**Response to Further
Information Request Ref.
No. ABP-320089-24**

Proposed Clonberne Wind
Farm, Co. Galway

Document Title: **Response to Further Information Request
Ref. No. ABP-320089-24**

**Drawing Title****Peat Harvesting Areas**

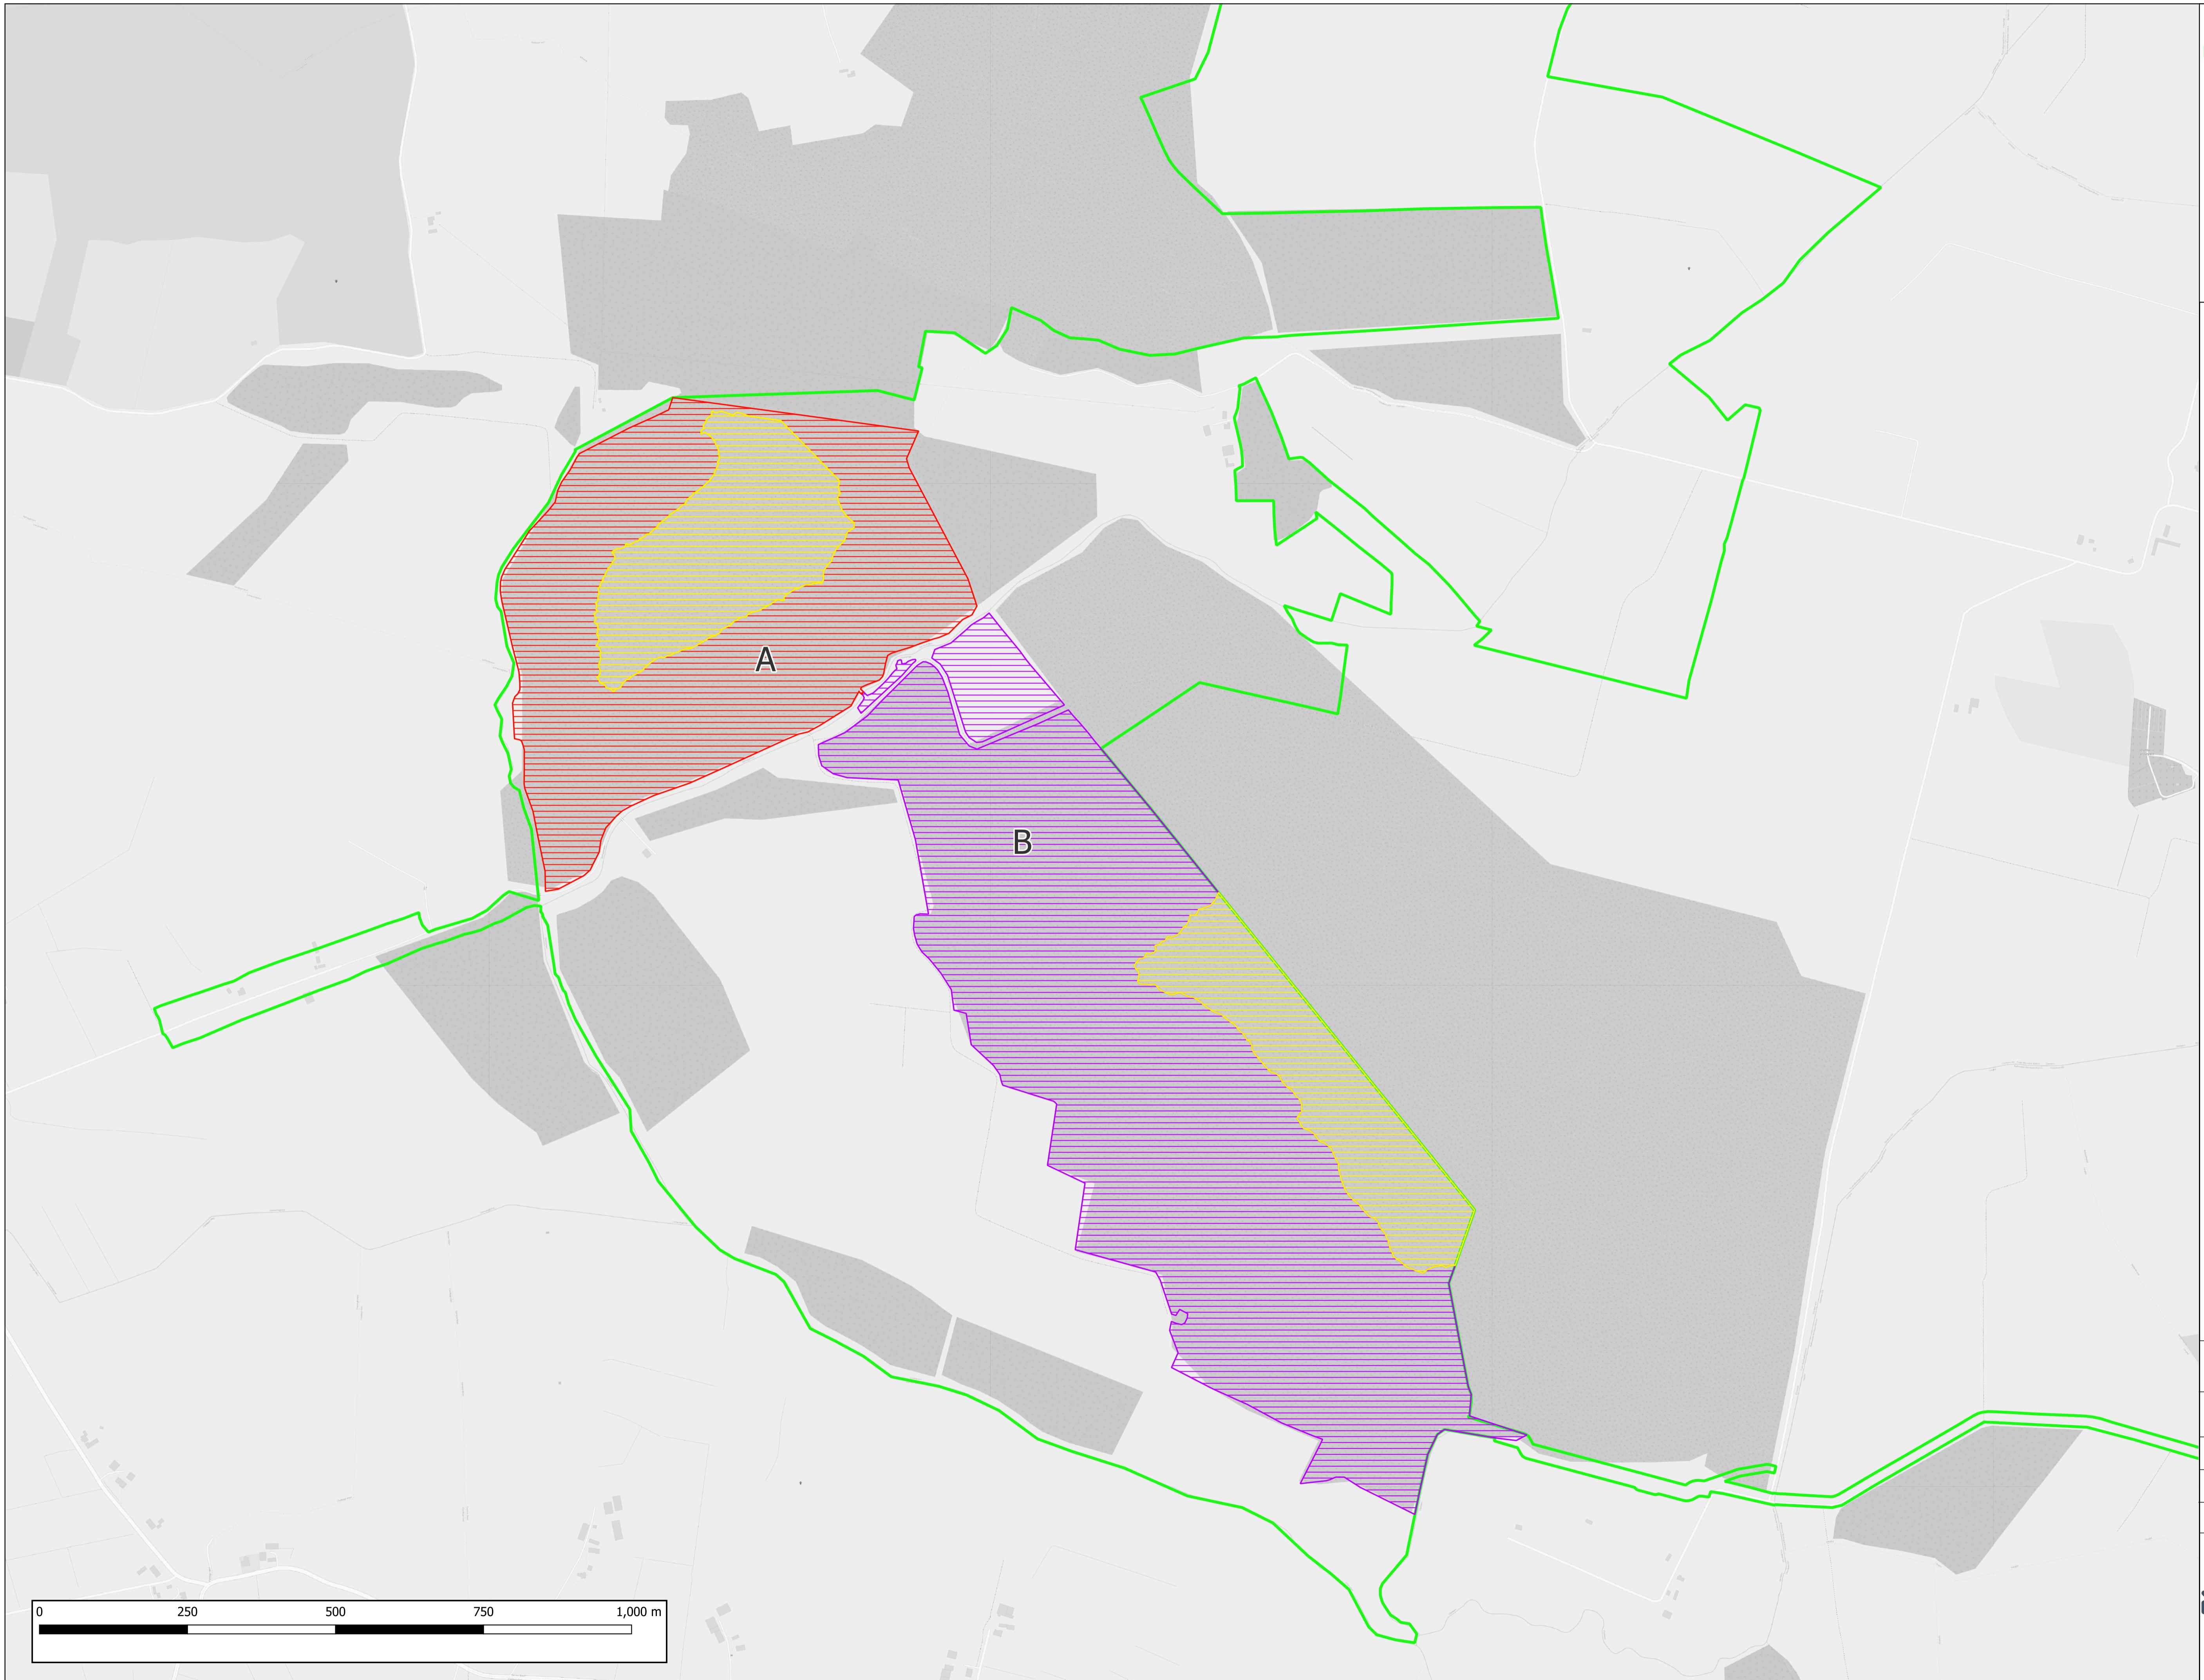
- a) *You are required to clarify the nature and extent of the peat harvesting area(s) within the site. The extent of the area(s) should be calculated and delineated on an appropriately scaled map(s).*
- b) *Confirm whether the Proposed Project is to utilise the drainage network installed for the purposes of this peat harvesting.*
- c) *Confirm whether peat harvesting is to continue during the lifetime of the wind farm and clarify that the proposed drainage plan can be effectively implemented whether or not peat harvesting is taking place.*
- d) *Confirm that should peat harvesting continue during the lifetime of the wind farm that it has been appropriately included and assessed in the EIAR and AA.*

- a) A drone survey was conducted in October 2025 to verify the extent of peat harvesting areas within the site. Approximately 109.2 hectares (ha) of the Proposed Wind Farm site has been subject to historic or current “peat harvesting” practices. Figure 2-1 delineates the areas within the site that have been or are subject to peat harvesting (Areas A and B). This figure also delineates areas of heavily drained, uncut raised bog, within which drainage channels have been installed to facilitate harvesting. These areas measure 20.6ha in total. The southernmost of these uncut raised bog areas is proposed for enhancement as part of the Proposed Project (as detailed in Section 4.3 of Appendix 6-6 of the EIAR). It should also be noted that peat harvesting activities in Area A are

- c) As stated within the response to item (a) above, peat harvesting activities in Area A are expected to cease at the end of 2025 and peat harvesting activities within Area B ceased approximately 4 years ago. On-site peat harvesting activities will, therefore, not occur in conjunction with the construction or operational phases of the Proposed Project. The integration and enhancement of the bog drains into the drainage system for the Proposed Project can be effectively implemented in the absence of peat harvesting activities being undertaken.

Figure 2-4: Extract from Figure 15-2c of the EIAR

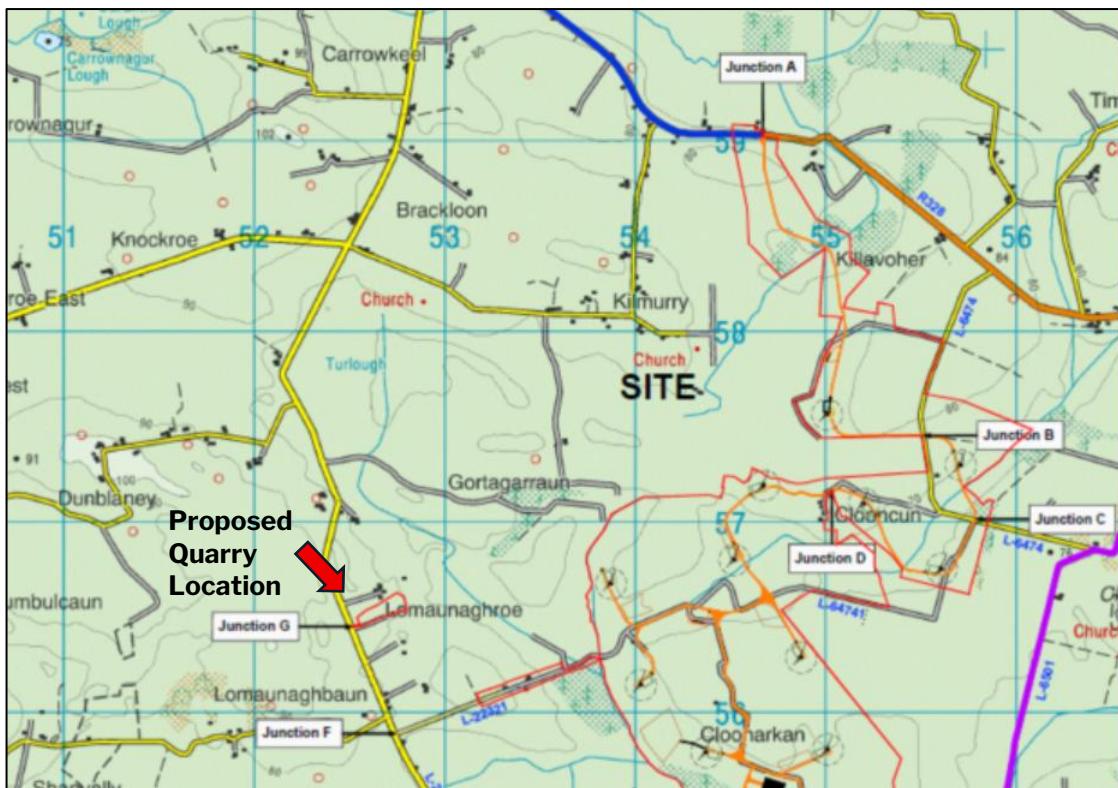
- *An observation is on file from a landowner at the junction of the N83 and the L6466 (Junction 9a) stating that he has not given his consent to the inclusion of his land or to the lodgement of the application.*
- *Junction 9b (bend on L-6466) appears to require the removal of a stand of trees/vegetation on lands along northern side of the L-6466 and the run-over area for the turbine plant deliveries encroaches on lands on the southern side of the L-6466 (i.e. Figure 15-23b of Appendix 15-4). This location is not included within the application but is included in the EIAR for assessment.*

The location of the junction on the L-2232 for the borrow pit is shown as Junction G on the extract from Figure 15-2c of the EIAR, and the junction between the L2232 and the L-22321 that provides access to the site is shown as Junction F. The total volume of material that will be extracted from the borrow pit and delivered to the Wind Farm site via the L-2232 and the L-22321 will be 106,770m³. Based on a conversion of 2.5 tonnes per m², and 25 tonnes per vehicle, this equates to 10,677 loads. As stated in Section 15.1.4.2.1 of the EIAR this stage of the construction will last 332 working days, resulting in an average of 32 loads delivered daily, or 64 HGV movements, or 153 pcus per day, on this section of the L-2232 and the L-22321. This will result in just over 3 HGV return trips per hour over a 10 hour day. As noted in Section 15.1.10 of the EIAR, both of these junctions will be attended by a Flagman during the construction stage, who will be in radio contact in order to co-ordinate movements. It is noted that there will be just one HGV movement being made at any one time, with no HGV travelling in opposing directions meeting.

The proposed Lomaunaghbaun Quarry (GCC file reference number 24/60013) is located opposite the proposed borrow pit on the L-2232 indicated as Junction G in the extract from Figure 15-2c of the EIAR inserted below as **Figure 2-4**. Upon review of the EIAR submitted with its application, it is identified that in the event that the Lomaunaghbaun Quarry is granted permission by the Commission, it will generate a maximum of 15 HGV trips to and from the quarry (or 30 movements daily, or 72 pcus), all of which will travel south on the L-2232 past Junction F that will be used for access to the Proposed Wind Farm site for HGV trips generated by the borrow pit. This equates to an average of 1.5 loads or 3 HGV movements per hour. The total HGV volumes that are forecast to be generated on the approx. 0.6km section of the L-2232 during the construction phase of the proposed Wind Farm, and by the
